UNITED STATES PATENT AND TRADEMARK OFFICE
CERTIFICATE OF CORRECTION

PATENT NO. : 6,032,898
APPLICATION NO. : 08/705326
DATED : March 7, 2000
INVENTOR(S) : LaCount et al.

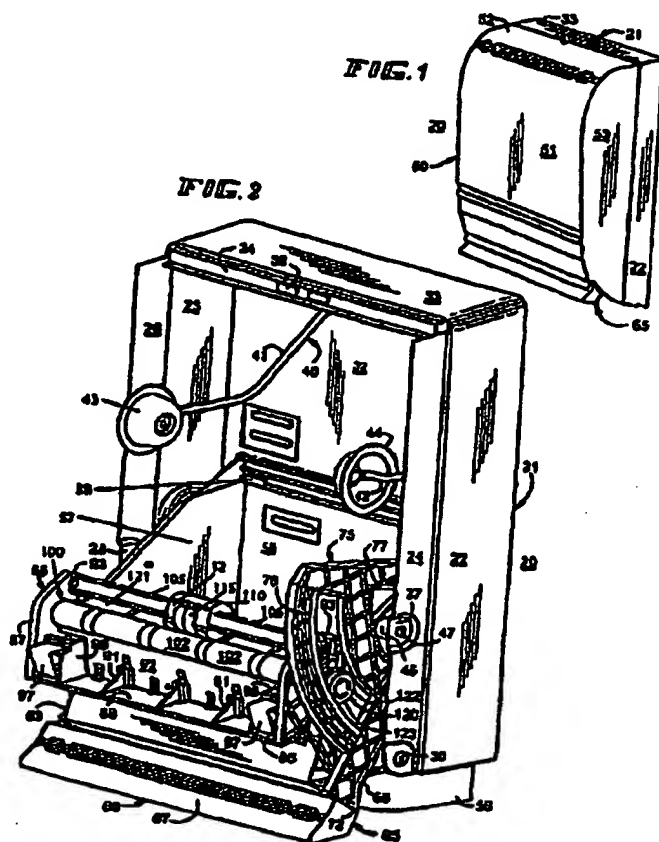
In the drawings, sheet 1, Fig. 2, reference numeral "22" on the sidewall of outwardly extending flange 24 should be deleted and reference numeral --27-- should be applied to the stamped portion;

In the drawings, sheet 1, Fig. 2, reference numeral --43-- should be applied to the left-hand side hub of the paper roll holder assembly 40; reference numeral --58-- should be applied to the rear wall of the chassis 55; reference numeral --57-- should be applied to the left-hand side spaced parallel side wall of chassis 55; reference numeral --38-- should be applied to the clip extending from the rear wall 32 of the housing 21.

In the drawings, sheet 1, Fig. 2, reference numeral --121-- should be applied to the drive roller segments of the drive roller 120.

In the drawings, sheet 1, Fig. 2, reference numeral --105-- should be applied to the transfer roller assembly; reference numeral --106-- should be applied to the shaft 106 of the transfer roller assembly 105; reference numeral --110-- should be applied to the transfer mechanism; reference numeral --112-- should be applied to the indented or removed portion of the cylindrical portion 111 of the shaft 106; reference numeral --115-- should be applied to the snap clip which receives the indented or removed portion 112 of the cylindrical portion 111 of the shaft 106.

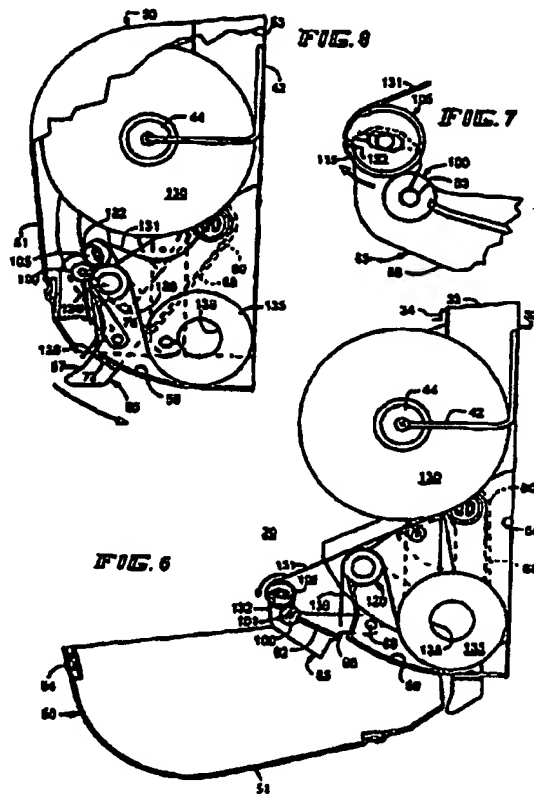
In the drawings, sheet 3, Fig. 6, the reference numeral "50" (not the reference numeral "50" pointing to the cover) should be deleted and reference numeral --51-- should be applied to the front panel of the cover 50.

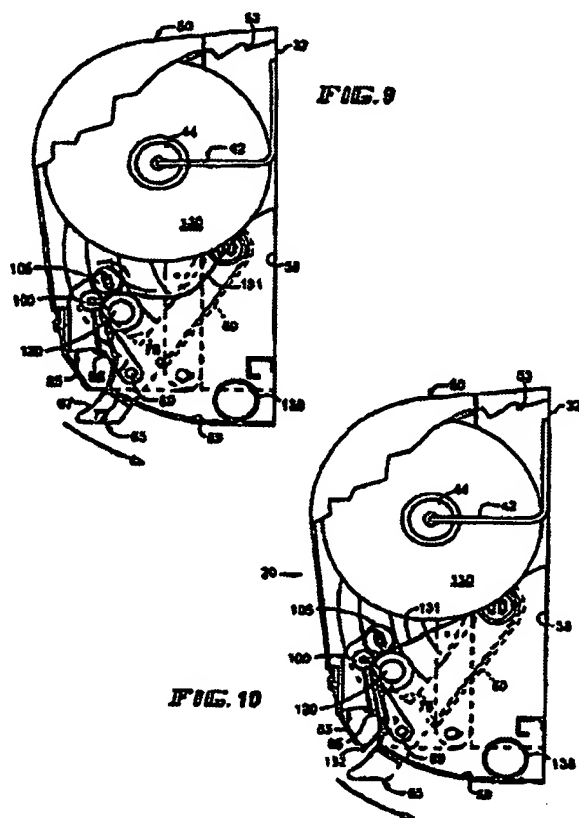
In the drawings, sheet 4, Fig. 10, the reference numeral "131" pointing to the free end of the flight of paper 131 should be deleted and the reference numeral --132-- should be applied to the free end of the flight of paper 131.

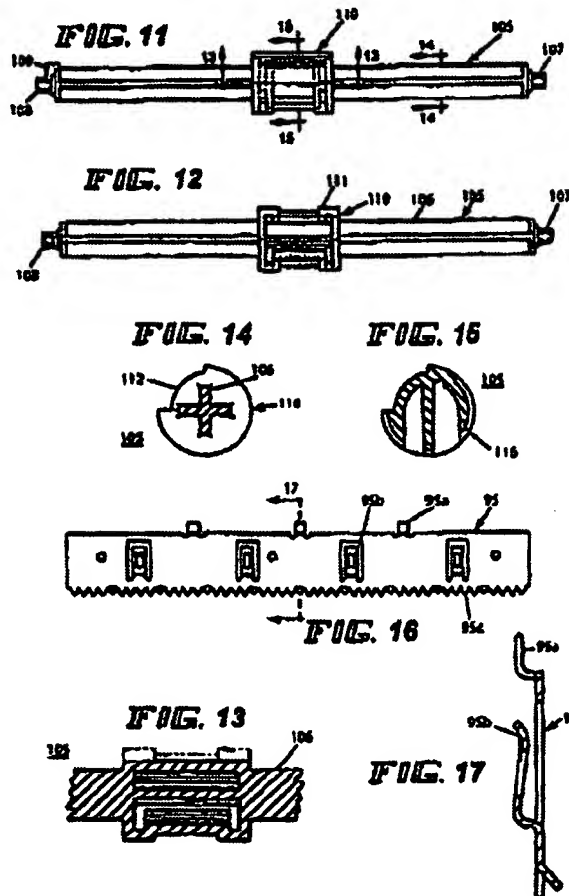
In the drawings, sheet 5, Fig. 11, reference numeral --105-- should be applied to the transfer roller assembly; reference numeral --107-- should be applied to the journal on the right-hand end of the transfer roller assembly 105; reference numeral --108-- should be applied to the journal on the left-hand end of the transfer roller assembly 105; reference numeral --109-- should be applied to the stop plate on journal 108; and reference numeral --110-- should be applied to the transfer mechanism positioned generally centrally of the shaft of the transfer roller assembly 105.

In the drawings, sheet 5, Fig. 12, reference numeral --105-- should be applied to the transfer roller assembly; reference numeral --106-- should be applied to the shaft of the transfer roller assembly 105; reference numeral --107-- should be applied to the journal on the right-hand end of the transfer roller assembly 105; reference numeral --108-- should be applied to the journal on the left-hand end of the transfer roller assembly 105; reference numeral --110-- should be applied to the transfer mechanism positioned generally centrally on the shaft 106; and reference numeral --111-- should be applied to cylindrical portion of the shaft 106.

In the drawings, sheet 5, Fig. 13, reference numeral --105-- should be applied to the transfer roller assembly; and reference numeral --106-- should be applied to the shaft of the transfer roller assembly.

In the drawings, sheet 5, Fig. 14, reference numeral --105-- should be applied to the transfer roller assembly; reference numeral --106-- should be applied to the shaft of the transfer roller assembly 105; reference numeral --110-- should be applied to the transfer mechanism positioned generally centrally of the shaft 106; and reference numeral --112-- should be applied to the indented or removed portion of the cylindrical portion 111 of the shaft 106.

In the drawings, sheet 5, Fig. 15, reference numeral --105-- should be applied to the transfer roller assembly; and reference numeral --116-- should be applied to the groove or receptacle of the cylindrical portion 111 of the shaft 106.

In the drawings, sheet 5, Fig. 16, reference numeral --95-- should be applied to the tear bar; reference numeral --95a-- should be applied to the tabs of the tear bar 95; reference numeral --95b-- should be applied to the clips of the tear bar 95; reference numeral --95c-- should be applied to the serrated edge of the tear bar 95; and section line --17--17-- should be added at the middle portion of the drawing at the top and bottom thereof.
